*Aerospace  
Safety  
Advisory  
Panel*

ANNUAL REPORT

COVERING CALENDAR YEAR 1986

Issued February 1987

## Field Joint Baseline Design

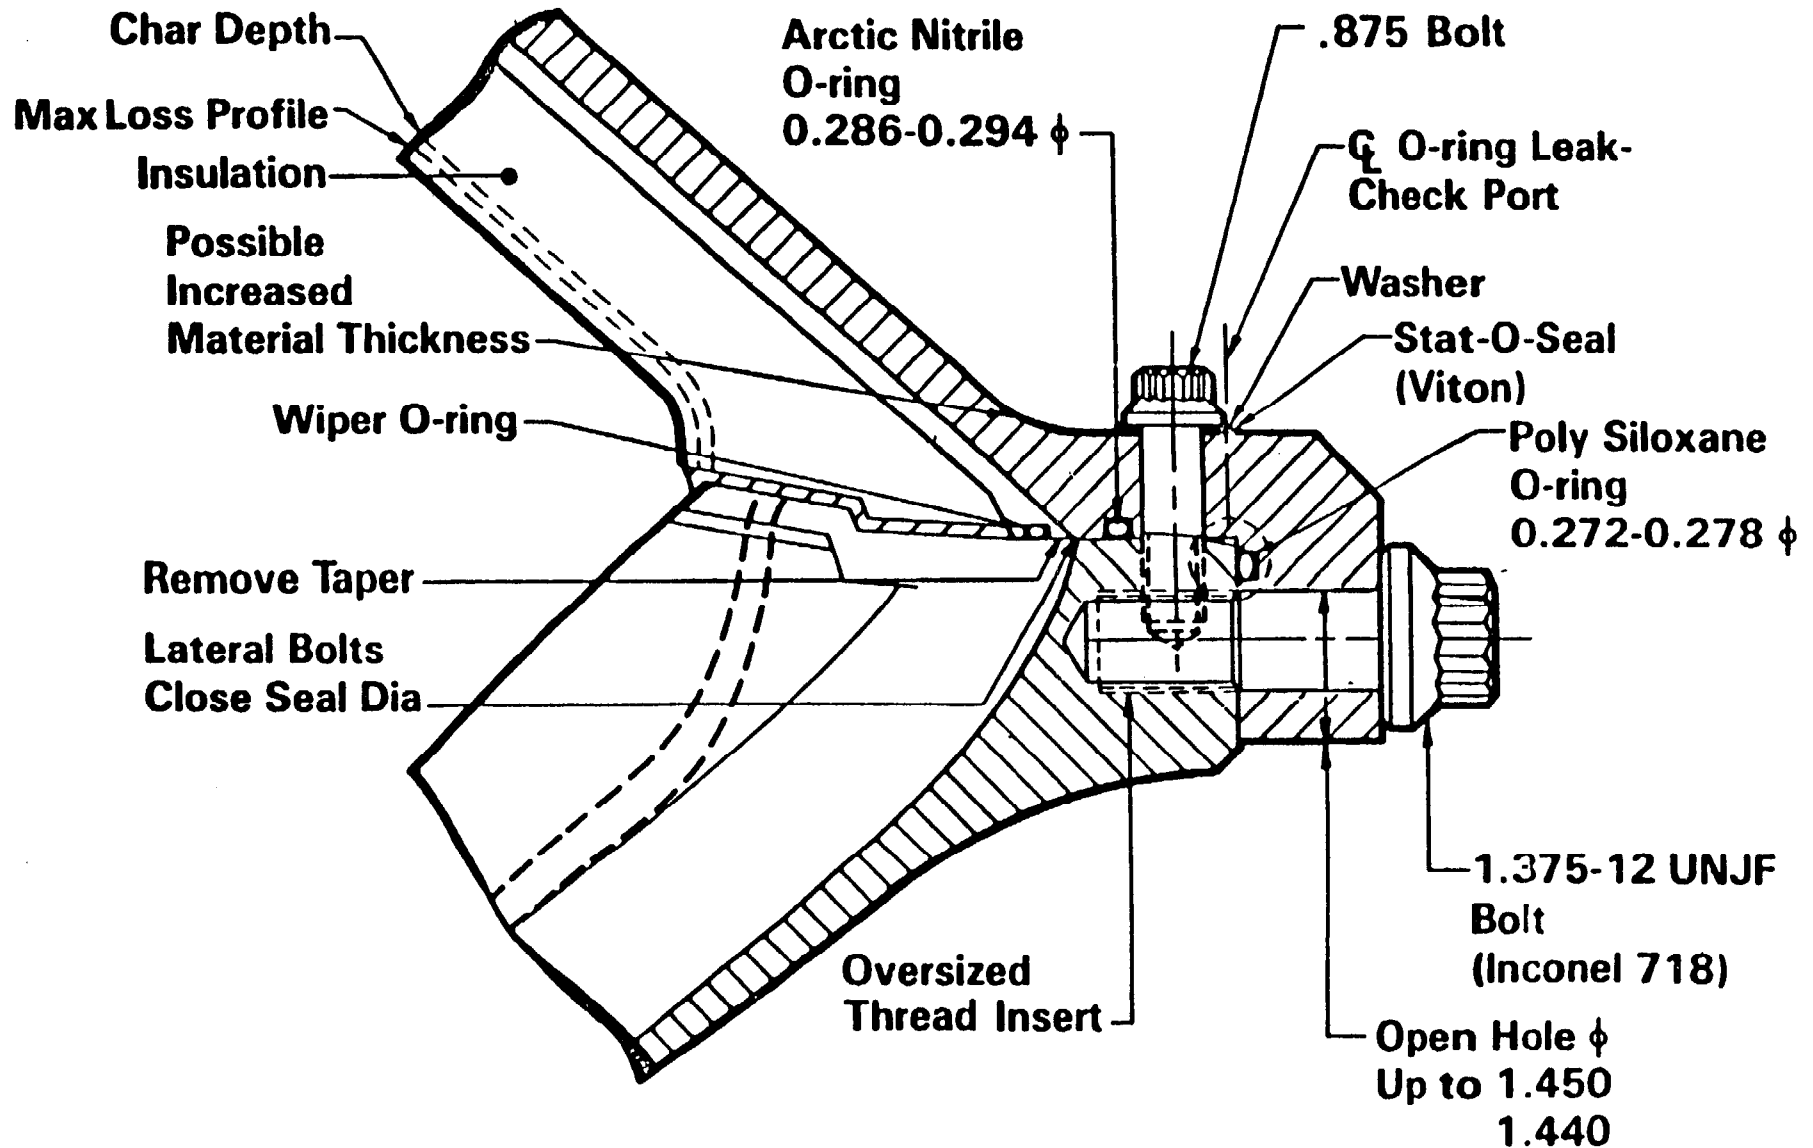
Case to Case Joint: The baseline field joint redesign chosen includes an interference-fit capture feature to minimize gap opening that results from joint rotation; three "O"-ring seals with two intervening test ports; improved unvented (bonded) insulation joint configuration to prevent hot gases from reaching the seals; larger seal gland widths to allow axial movement; and a joint heater to control temperature at the seals. Seal materials with improved resiliency and grease compatibility may eliminate the need for joint heaters.

There are a number of unresolved design questions at this time. Among them are the possibility of hot gas jet impingement or circumferential flow of such gas that could result from an insulation debond, and the ability to disassemble the nozzle from the case without damage to the insulation. Two alternate designs are being considered. One incorporates a metal thermaloc U-seal which maintains contact with the nozzle fixed housing and case aft dome during pressurization. The other concept is to insulate over the case-to-nozzle joint making it a factory joint. This design requires a new "field type" joint in the aft segment case and a redesign of the aft propellant grain. Other contractors have proposed a design wherein joint rotation acts to close the joint against the seal but, unfortunately, this approach probably requires a new forging with attendant schedule impact.

General: The Panel is of the opinion that the redesigned joint is an improvement over the original and can result in a safe structure. Mating, demating, and re-use of the baseline configuration may prove to be a problem, however. Proof of the suitability of the redesign depends critically on achieving satisfactory results from a thorough, carefully planned, conducted, and instrumented test program. At present there is not sufficient definition of the development and certification test programs to permit comment as to their adequacy.

## Case-to-Nozzle Baseline Joint Configuration

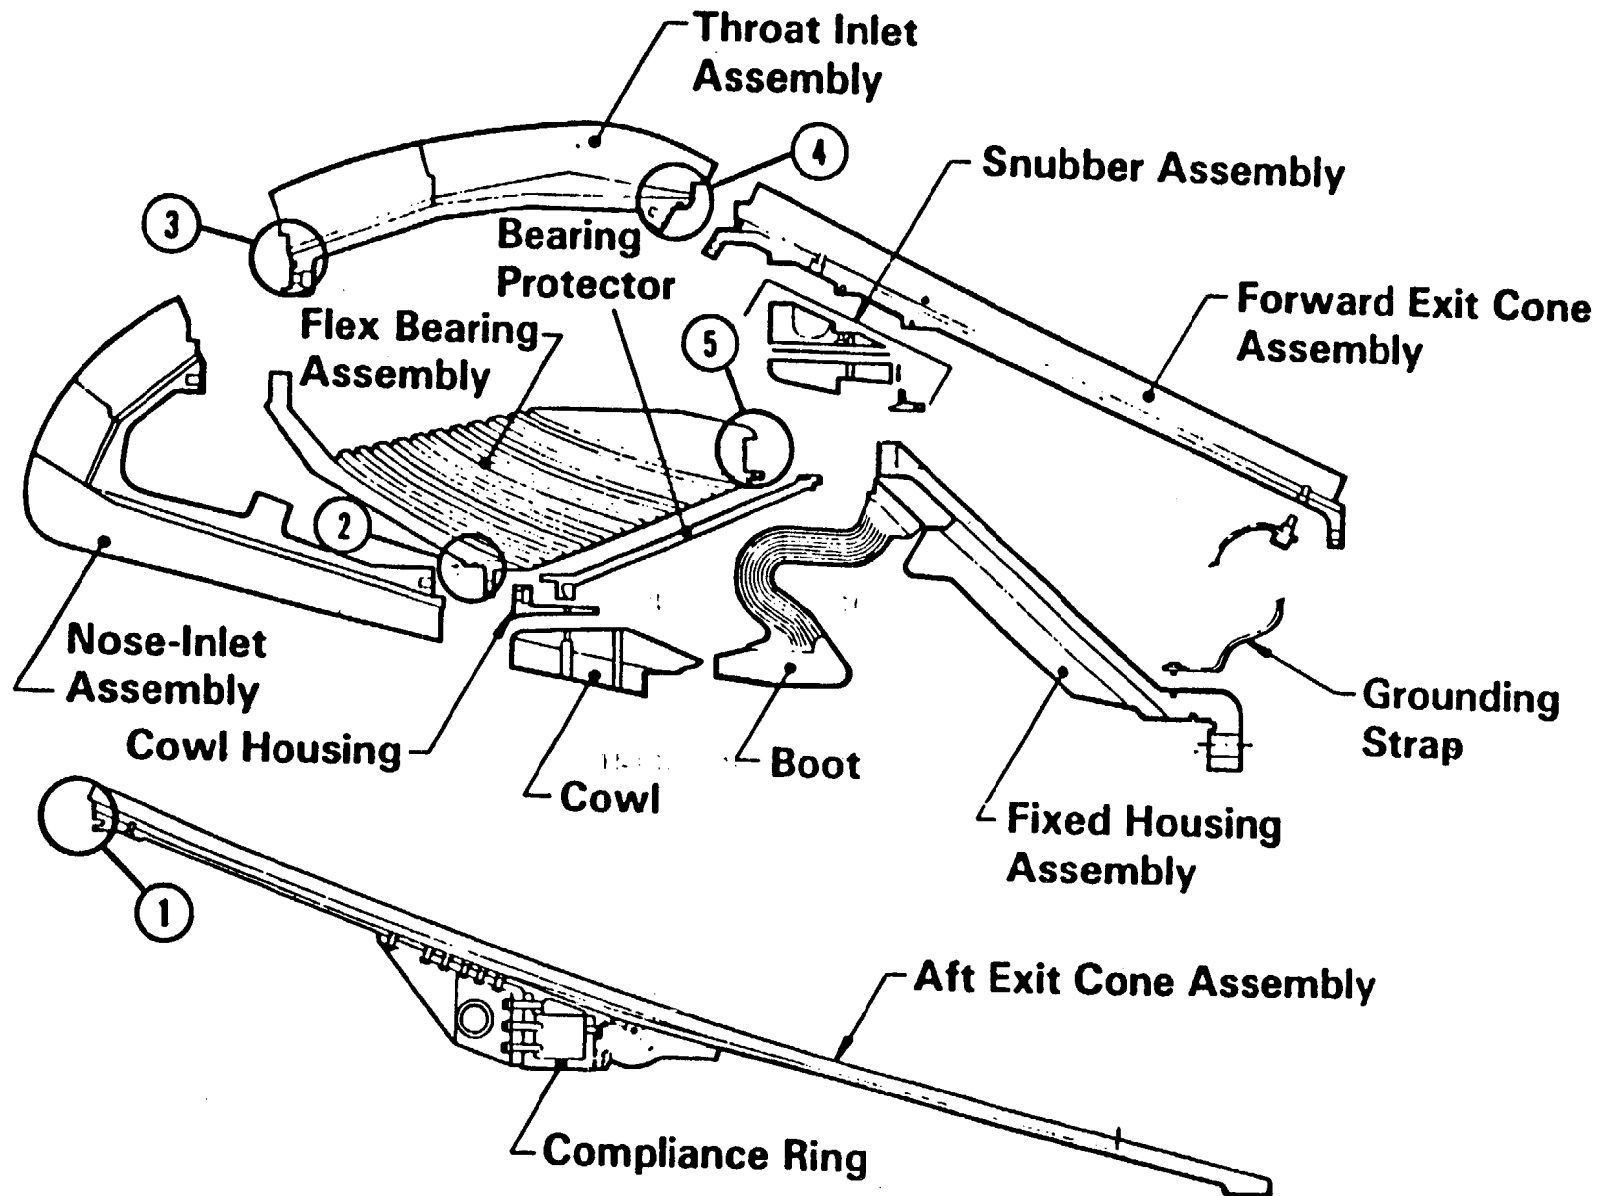
Nozzle System: The existing nozzle seals have performed adequately to date. The new design requirement for redundant and verifiable seals has, however, resulted in a complete redesign of all these seals. All such nozzle internal joints (there are five) are being revised to contain two seals with an intervening
